Project: ScottishPower Renewables East Anglia ONE North and East Anglia TWO Offshore Wind Farms Grid Connection Review

## ScottishPower Renewables East Anglia ONE North and East Anglia TWO Offshore Wind Farms Grid Connection Review

Suffolk County Council (SCC) engaged AFRY to provide technical assistance to inform and support SCC's representations to the Planning Inspectorate in response to SPR's applications, through the review of selected documents from the DCO Application submissions and reporting on their findings.

Figure 1 – Distance of the Friston Substation site from the shoreline

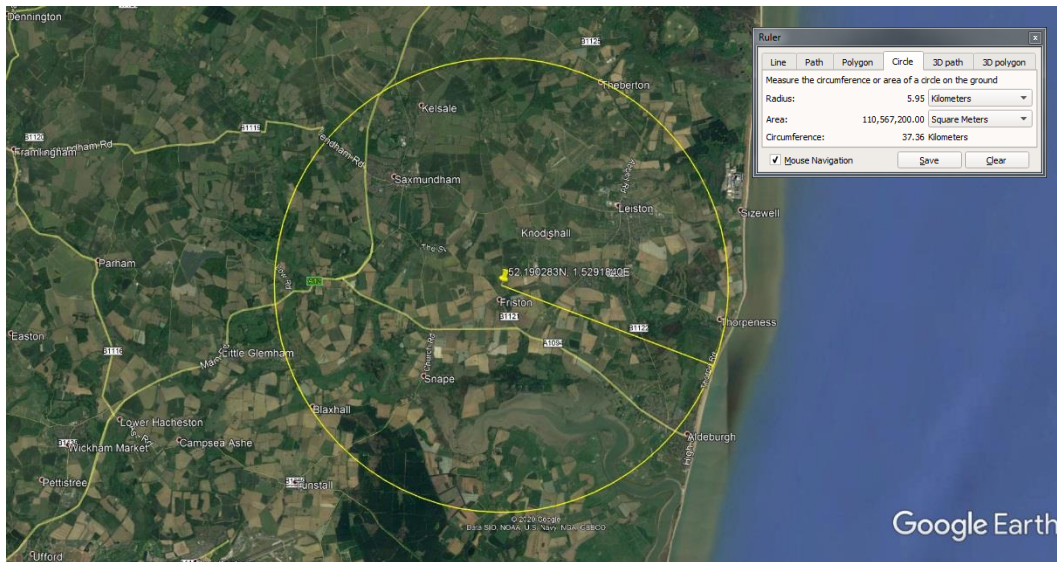
The location that has been proposed, Grove Wood, Friston is at 52.190283N, 1.5291840E (Grid Reference TM 41318 60543). This is 5.9 km from the shoreline (see Figure 1) and is not located adjacent to, or within the stated distances from, the specified pollutant sources, and therefore it is not considered to be a Class IV pollution severity site according to the criteria above.

The documents indicate a land area of 44,950 m<sup>2</sup> compared with 16,800 m<sup>2</sup> for a GIS substation footprint (Table 6.28). It is noted that Bramford substation (to which EA1 is connected) is 23 km from the sea.

*Figure 2 - East Anglia ONE Substation near NGET Bramford*

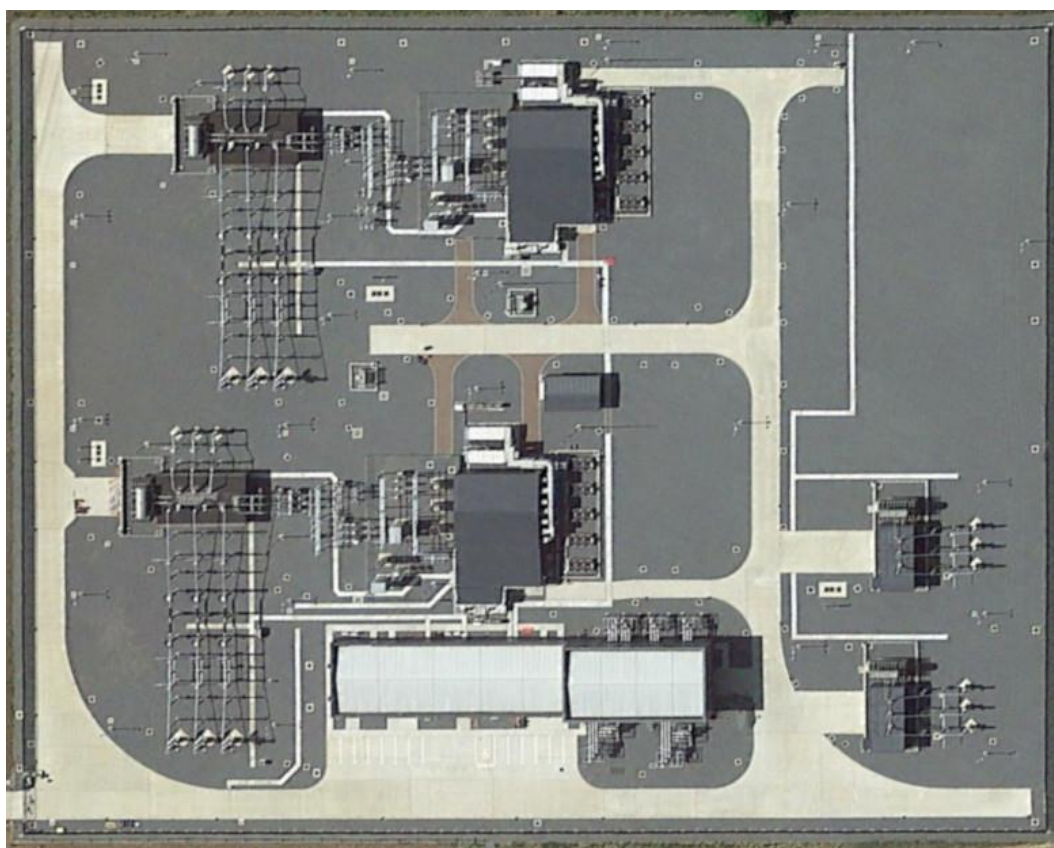
Comparing this with the representations produced for the EA1N and EA2 projects, there appears to be a lot of space between the static compensators (statcoms) and the internal

road suggesting a possible location for AIS 220 kV switchgear instead of the GIS switchgear shown towards the bottom. The control building does seem to be rather large (13 x 40 m) but perhaps accommodates office, messing, etc. and suggests that some of the facilities could be shared between EA1N and EA2.
